MINUTES FROM TECHNICAL REVIEW COMMITTEE MEETING 23 AUGUST 1989 NCBC  
GULFPORT MS  
10/5/1989  
NCBC GULFPORT

CBC GULFPORT  
TECHNICAL REVIEW COMMITTEE MEETING MINUTES  
23 AUGUST 1989

*PHASE II*  
COMMENTS FOR THE FINAL VERIFICATION REPORT  
NAVAL CONSTRUCTION BATTALION CENTER (NCBC)  
GULFPORT, MISSISSIPPI

We have recently reviewed the Final Verification Report for the Naval Construction Battalion Center (NCBC) located at Gulfport, Mississippi. The purpose of this review is to evaluate the analytical data and recommend additional work that will satisfy the requirements under the Comprehensive Environmental Response Compensation and Liability Act (CERCLA). Six sites are included in this study and include a fire fighting training area, a disaster recovery disposal area, and four other landfill/disposal areas. Figure 1 shows the location of these sites and table 1 lists the chemical parameters identified for analysis of sediment, soil, and water samples at NCBC for this study.

Figure 2

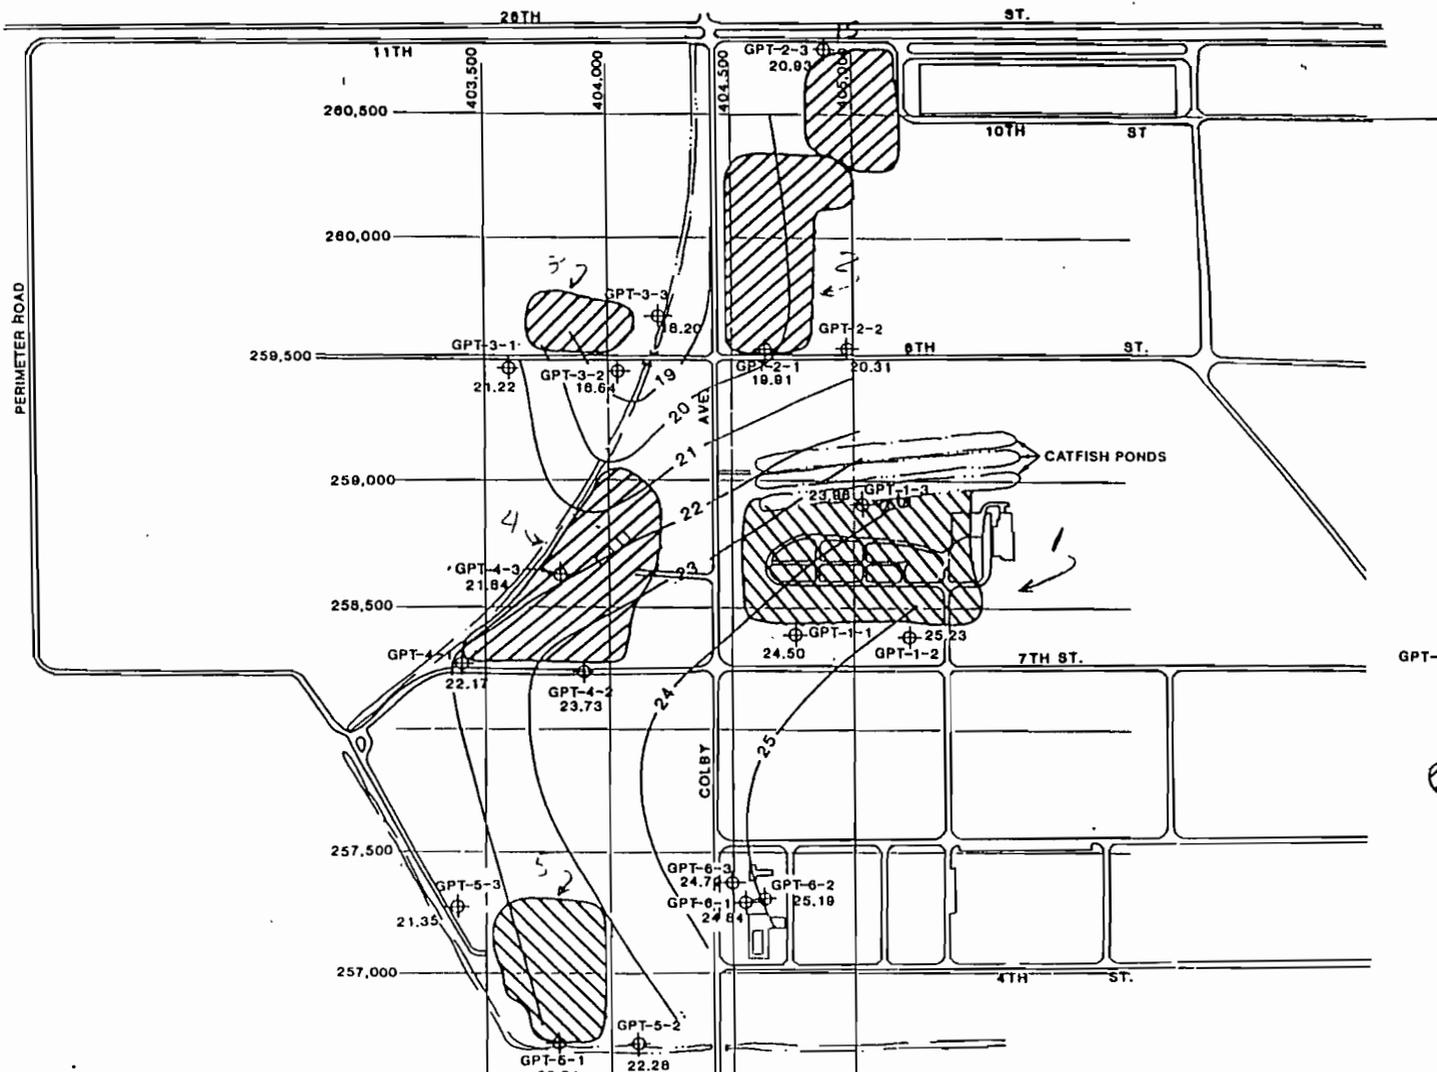
Only one round of water level measurements were taken in the surficial aquifer at the NCBC facility. These measurements indicate that the hydraulic gradient slopes in a direction different than originally presumed (figure 2). This has resulted in the placement of an inadequate number of downgradient monitoring wells at Sites 1 through 5, and possibly at Site 6. The Final Verification Report recommends that before additional monitoring wells are installed at these locations, further rounds of water level measurements should be collected. It was noted in the report that several inches of precipitation had occurred at the facility in the weeks that preceded the water level measurements. This rainfall had the effect of raising water levels to above normal and may have also affected the slope of the potentiometric surface. Quarterly water level measurements would determine if seasonal and/or local effects cause significant variations in the hydraulic gradient and the direction in which it slopes. This information is necessary to determine if future monitoring wells are correctly placed and that an adequate number are installed.

**GROUNDWATER MONITORING WELL AND SAMPLING LOCATIONS - SITE 1**  
 NCBC Gulfport  
 Gulfport, Mississippi

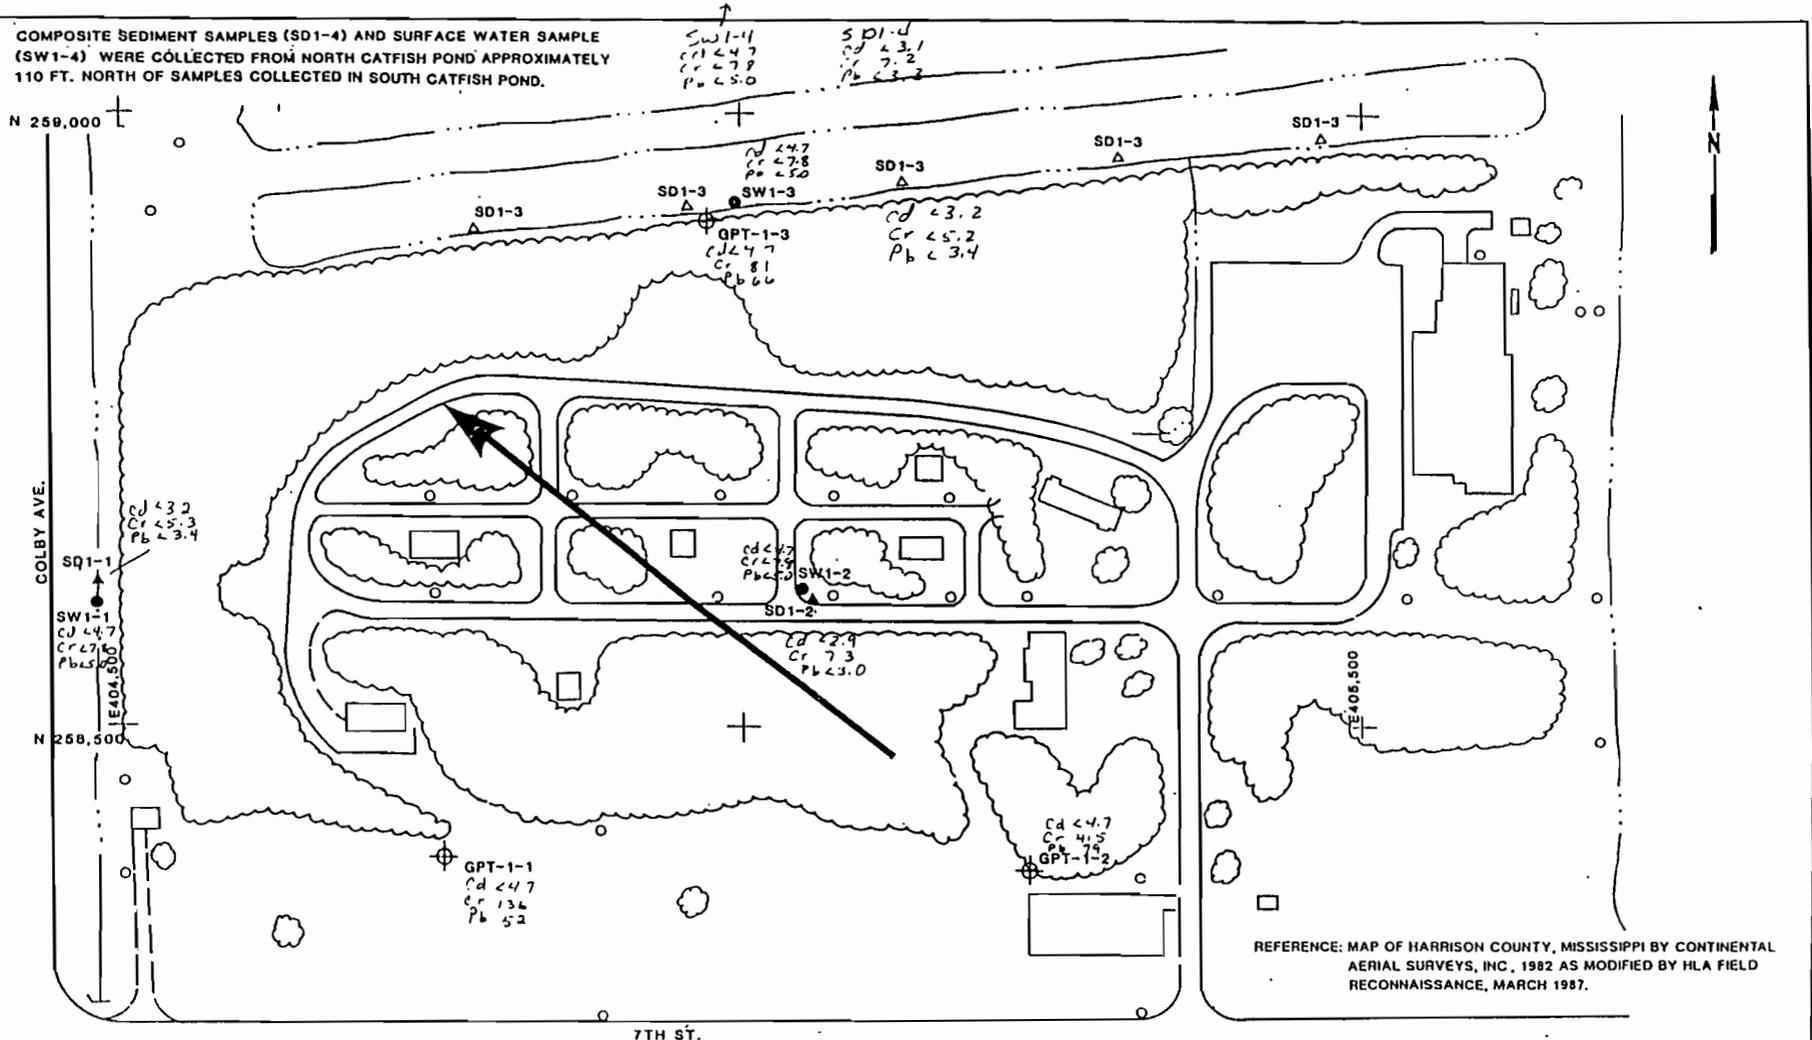
Analytical results for groundwater samples taken from all three monitoring wells at site 1 indicate that levels of chromium and lead are above the Maximum Concentration Levels (MCLs) as specified in the Safe Drinking Water Act (figure 3). The highest concentrations of chromium and lead were encountered in well GPT-1-2. As stated previously, the report recommends that the wells be resampled to verify contaminant concentrations. The installation of additional

downgradient well are necessary pending confirmation of the potentiometric surface configuration.

Figure 4

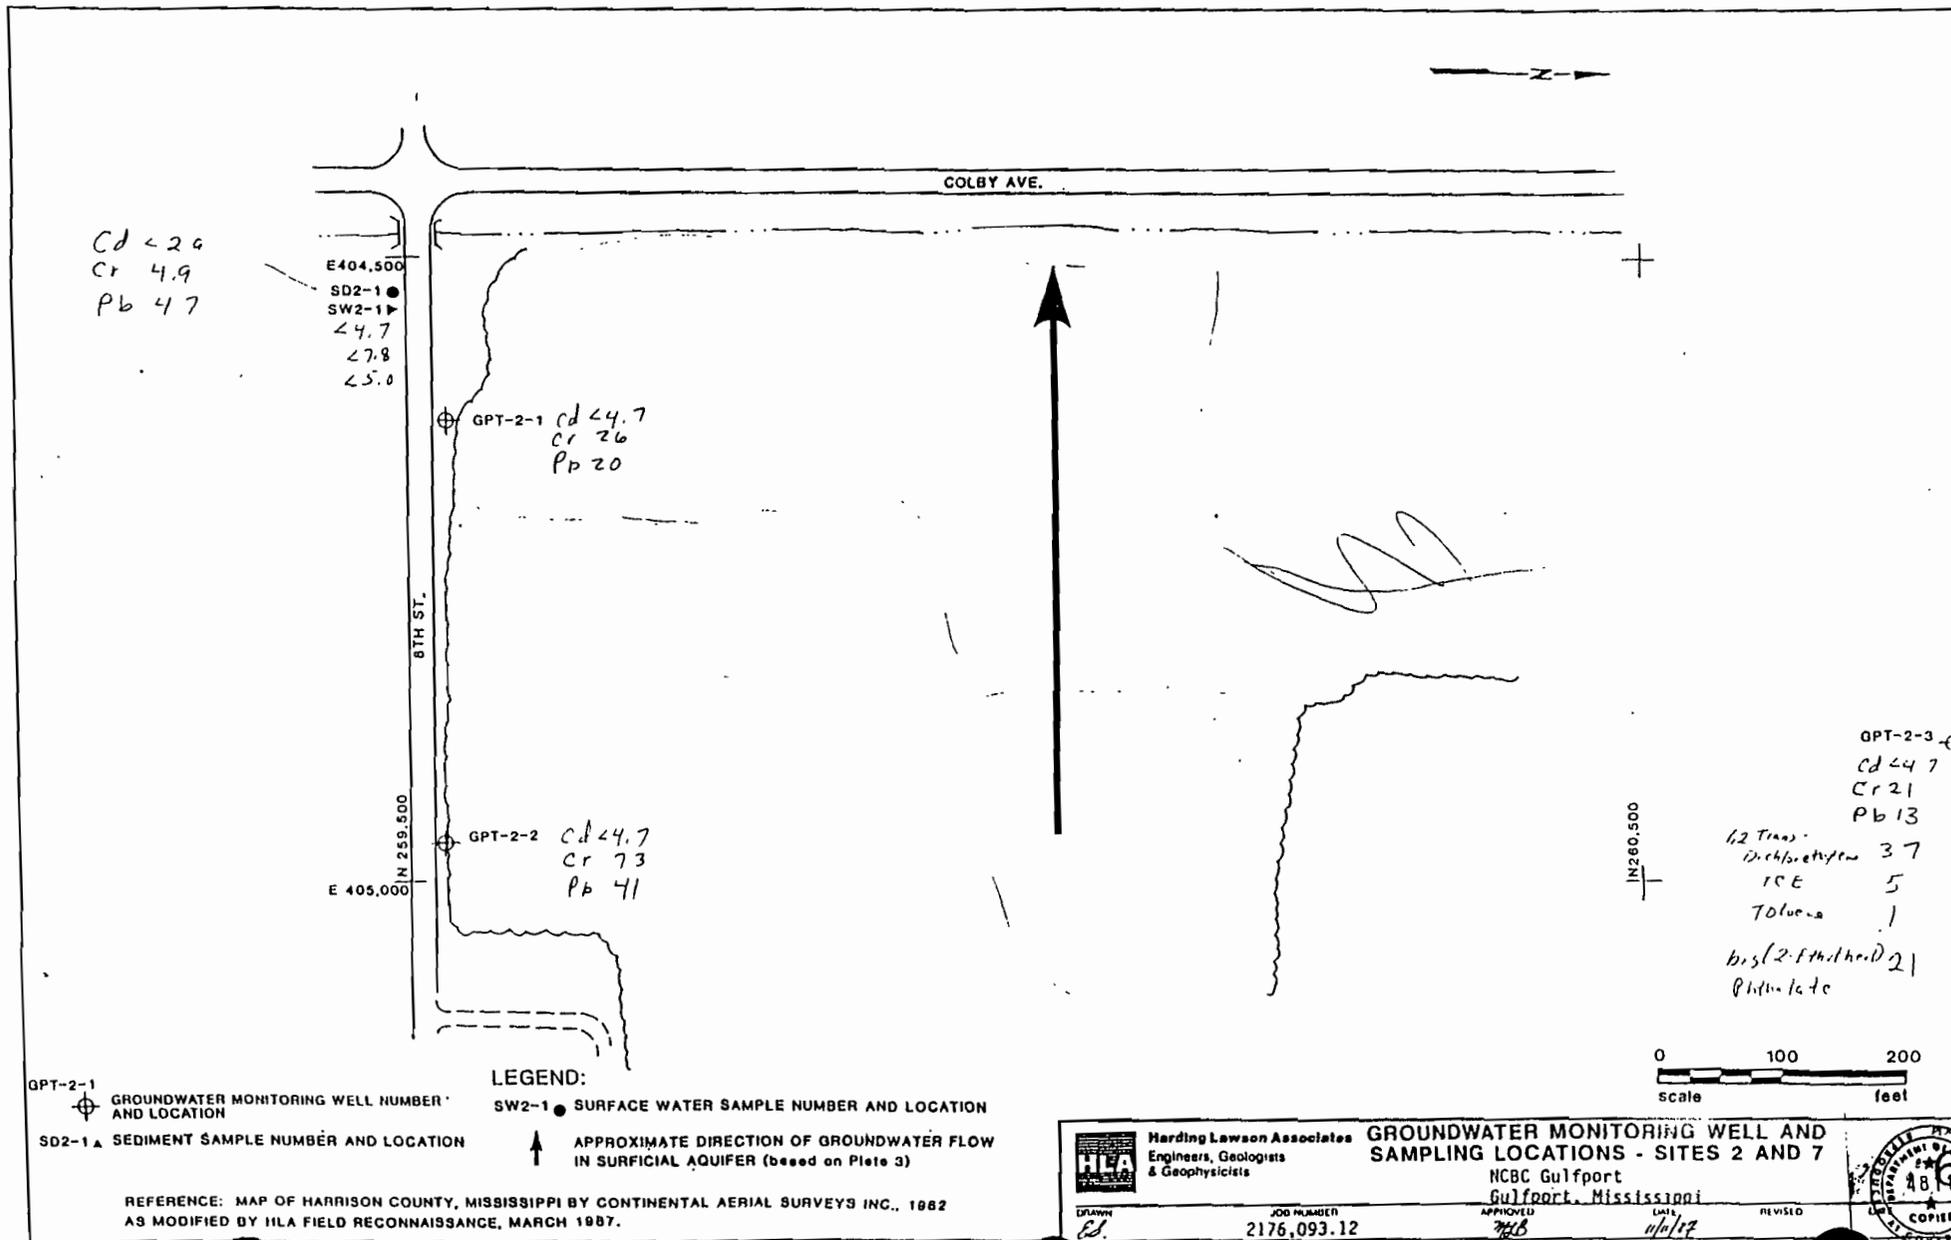
Analytical results for groundwater samples at Site 2 indicate an elevated concentration of chromium in well GPT-2-2 (figure 4). The value obtained was 73 ppb, which is in excess of the MCL of 50 ppb. Lower concentrations of chromium and lead were detected in wells GPT-2-1 and GPT-2-3, but did not exceed the MCL.

Trichloroethylene (TCE) was detected at a concentration of 5 ppb (equal to the MCL) in a sample from well GPT-2-3. This well is screened at the shallowest interval of any well at the facility and was presumed in the report to encounter the lower confining clay at a depth of 13 feet. Most wells at the facility encounter the lower confining clay at depths in excess of 20-25 feet. The possibility exists that well GPT-2-3 encountered a discrete clay lense above the lower confining clay unit. Because TCE is denser than water, and if there is additional sand below a shallow clay layer, there is a possibility that TCE may be contaminating groundwater at a deeper interval at this site. Further characterization of the clay unit in this area will be necessary to determine if such contamination has occurred.

In addition, 1,2-trans-Dichloroethylene was detected in well GPT-2-3 at a concentration of 37 ppb, as was a trace of toluene and chloroform. The Bureau concurs with the report which recommends additional sampling in order to evaluate the significance of the contamination in these wells.

None of the monitoring wells at Site 2 were in the downgradient direction. Pending further water level measurements, additional monitoring wells will be necessary to fully assess this site.

Harding Lawson Associates Engineers, Geologists & Geophysicists	<b>GROUNDWATER MONITORING WELL AND SAMPLING LOCATIONS - SITE 3</b>		
		NCBC Gulfport Gulfport, Mississippi		
DRAWN JUD PRAMMEL 2176,093.12	APPROVED 	DATE 11/4/87	REVISIONS 	DATE

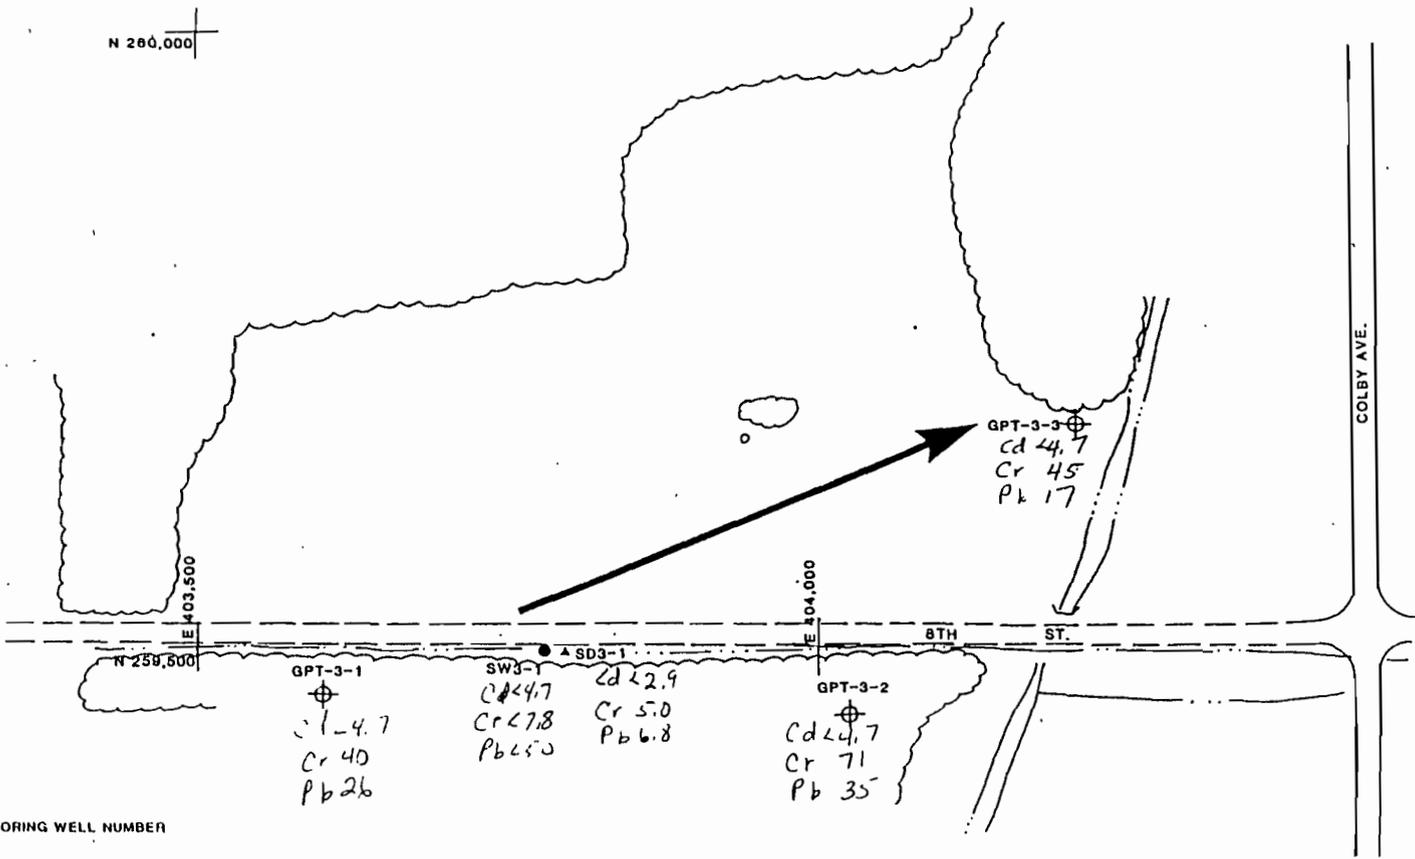
Metals were the only contaminants detected in the groundwater samples from Site 3 (figure 5), and all metals levels were below the MCL. Resampling to verify contaminant concentrations is recommended, as is installation of additional downgradient monitoring wells after confirmation of the configuration of the potentiometric surface.

<b>Harding Lawson Associates</b> Engineers, Geologists & Geophysicists	<b>GROUNDWATER MONITORING WELL AND SAMPLING LOCATIONS - SITE 4</b> NCBC Gulfport Gulfport, Mississippi	
	DRAWN <i>ES</i>	JOB NUMBER 2176,093.12

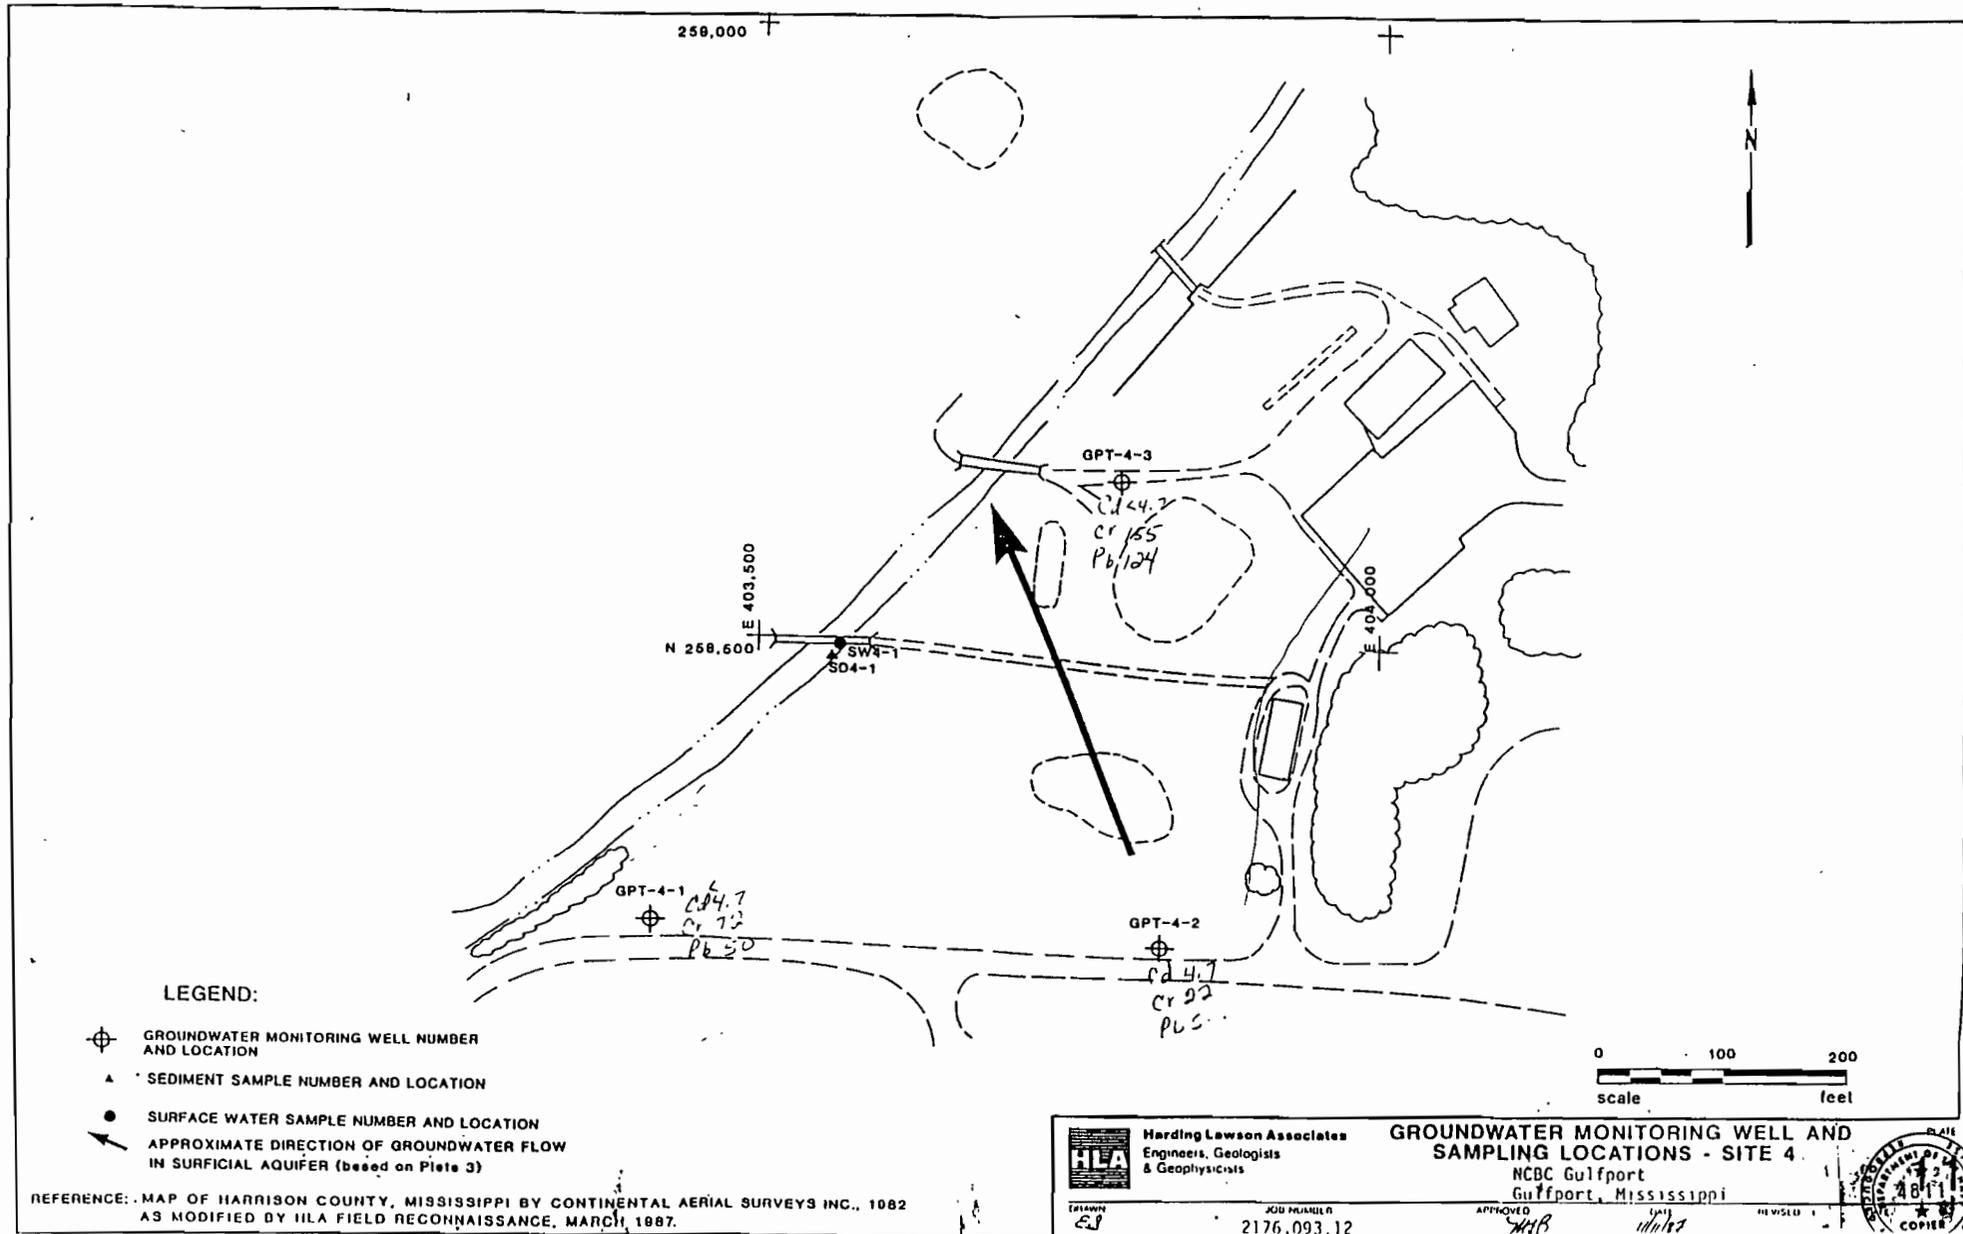
There were no volatile organic, acid-extractable, or base-neutral contaminants above detection limits for all monitoring wells at Site 4 (figure 6). Chromium concentrations for samples taken from wells GPT-4-1 and GPT-4-3, however, were above the MCL of 50 ppb at concentrations of 72 ppb and 155 ppb, respectively. Lead concentrations for the same two wells were 50 ppb and 124 ppb (MCL = 50 ppb). Levels of chromium and lead below the MCL were detected at well GPT-4-2 and levels below the RFI health based criteria were found in sediment sample SD4-1. Resampling of all wells is recommended to confirm these contaminant levels. Additional downgradient wells are needed, but as always should be installed only after further groundwater measurements confirm slope of the potentiometric surface at this site.

Another area of concern involves the past practice of disposing of MEK at Site 4. This compound was not included in the list of chemical parameters analyzed for at this facility. MEK should be added to this list and analyzed for in any future sampling events.
